## SECTION 4: SAFETY ISSUES

This section discusses the safety issues encountered both during the initial desktop study and the nine site inspections of seal extension projects discussed in Section 1. It should be noted that some projects were up to five years old and practices observed may no longer be in use.

**PHOTO 1 - STEEP FEATHER EDGE SLOPE**

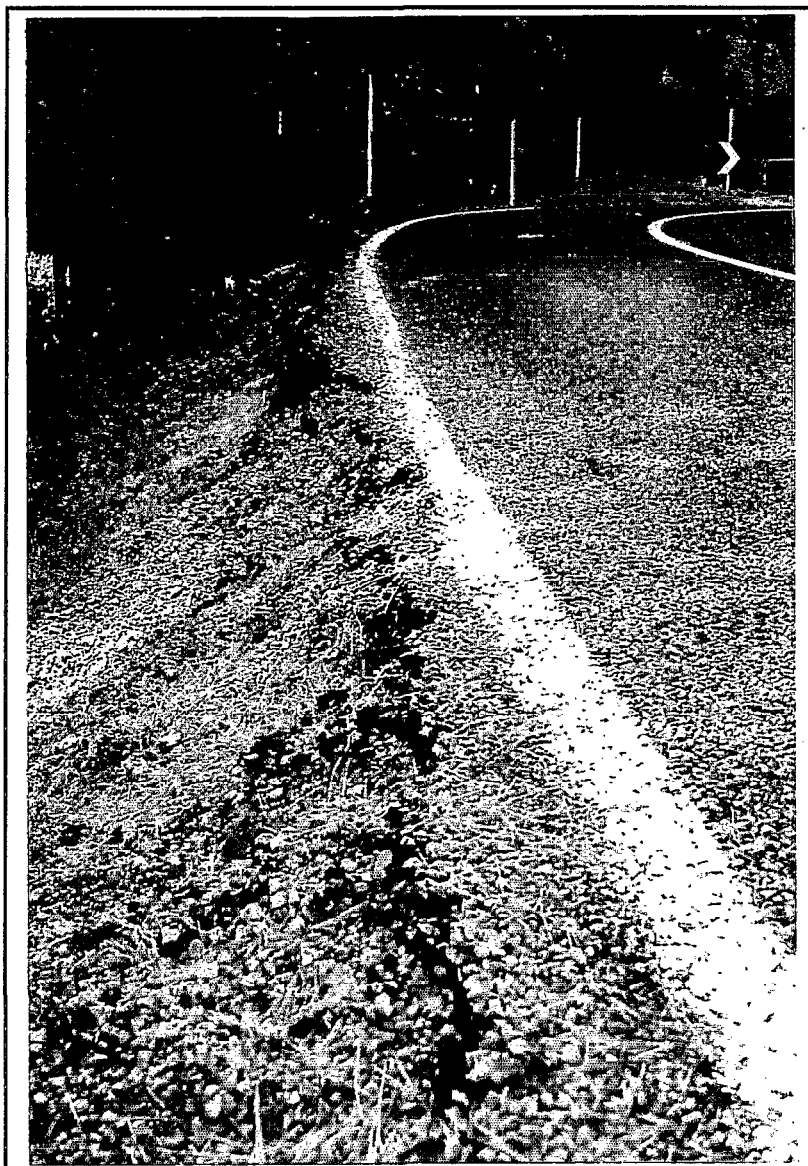
The seal width (typical) on most projects was in the range 5.5m to 6.0m and generally not considered a safety problem. What was of most concern was the practice of achieving the additional seal width by steepening the feather edge slope. **This compromises both safety and the structural integrity of the seal edge and significantly increases future maintenance costs.** This issue is discussed further in Section 4.8: Feather Edge Slopes.

Note lack of edge support, edge break occurring,  
edge line too close to edge of seal

Ideally a feather edge of 5 to 1 should be provided to allow vehicles to safely pull over off the seal. However, it is accepted that for seal extensions with low traffic volumes this is often unrealistic. (Refer photo 1 on page 22).

**PHOTO 3 - INTERSECTION DELINEATION/MARKINGS**

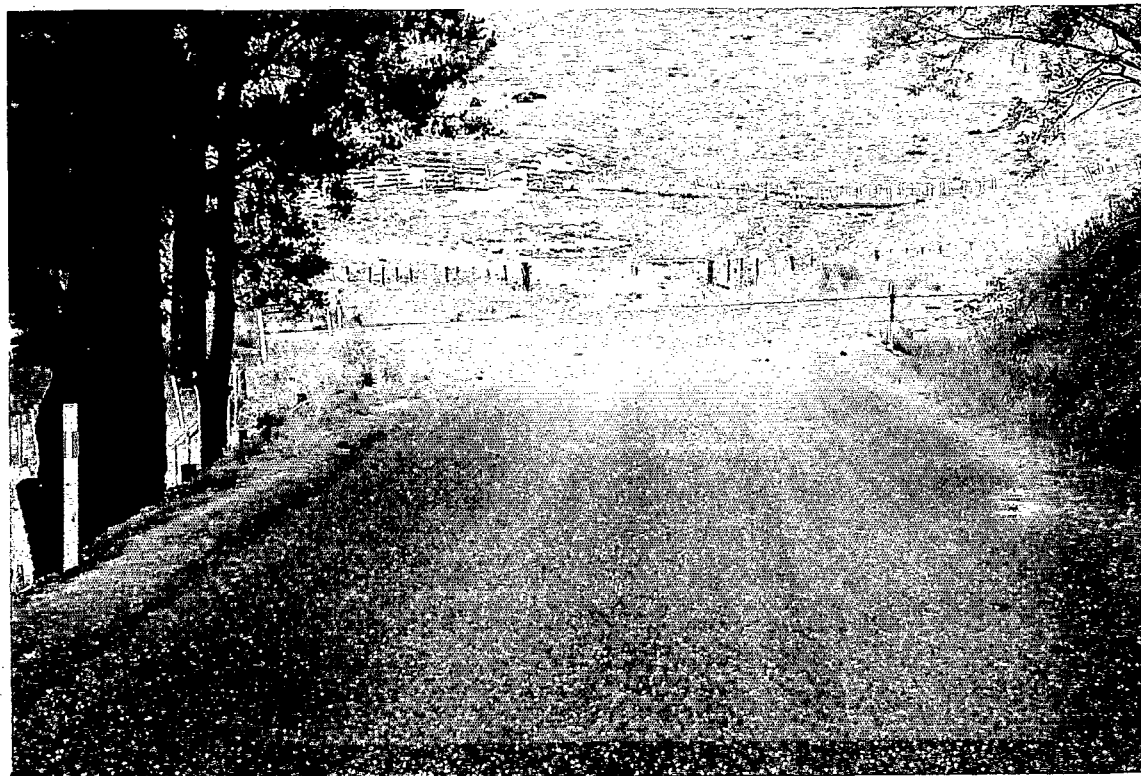
Photo 3 on page 25 shows one project where the main route turned to the left and the side road to the right. The roads in both directions were concealed and tyre marks suggested to drivers that the main route was to the right. The intersection finger boards were hidden by trees and not visible until almost at the intersection.

Both roads are concealed and the tyre marks suggest that the main route is to the right (the main route is to the left).

*That Transfund require all designs to comply with good practice/approved standards and guidelines. Additional attention must be given to intersections and access ways at both design, construction and post construction stage. This issue is discussed further in Section 3.5: Post Construction Safety Audits and Section 3.6: Standards.*

**PHOTO 4 - RETAINING WALLS**

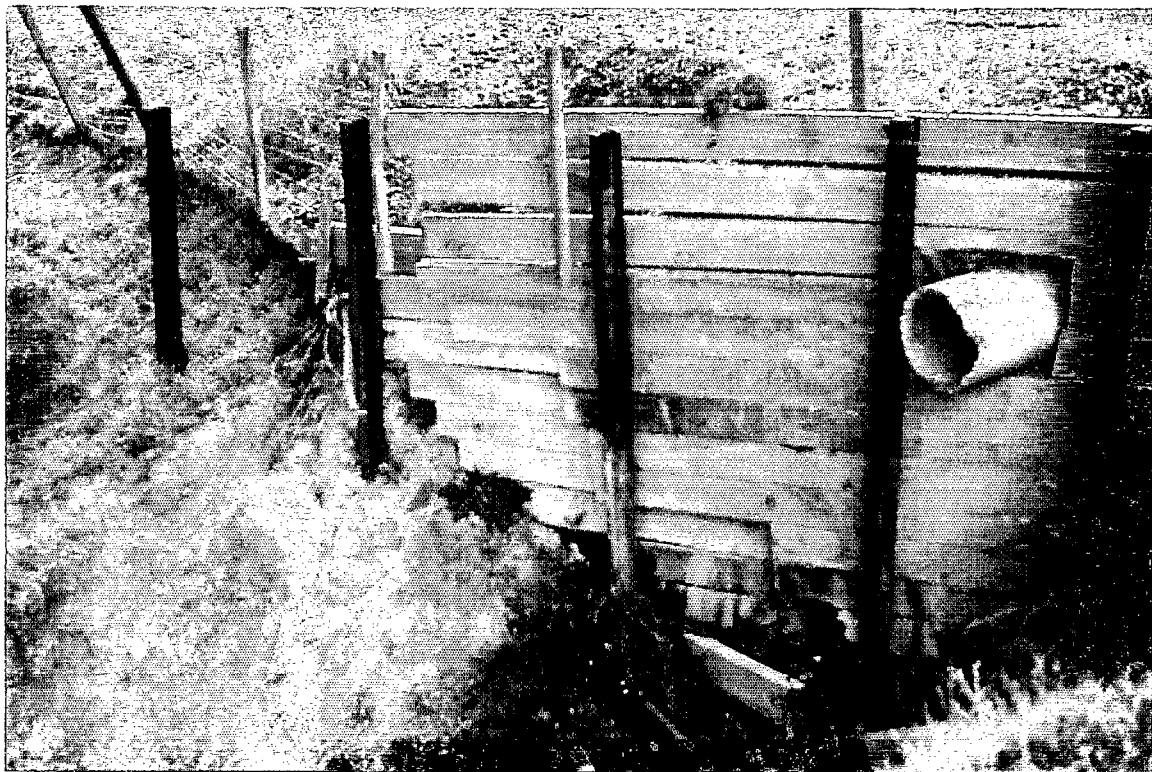
Several retaining walls were poorly constructed and failures had or were occurring. Some obviously had not been designed for the height to which they had been constructed. Also a high proportion were not part of the original project but appeared to be required as a result of inadequate investigations/poor design.

Note the poor design / construction - the uprights have moved significantly and the wall is failing.

*That Transfund require scheme assessments/final designs adequately investigate the need for retaining walls. Road Controlling Authorities must ensure that retaining walls are properly designed and the design height is not exceeded. See also Section 3.3: Scheme Assessments.*
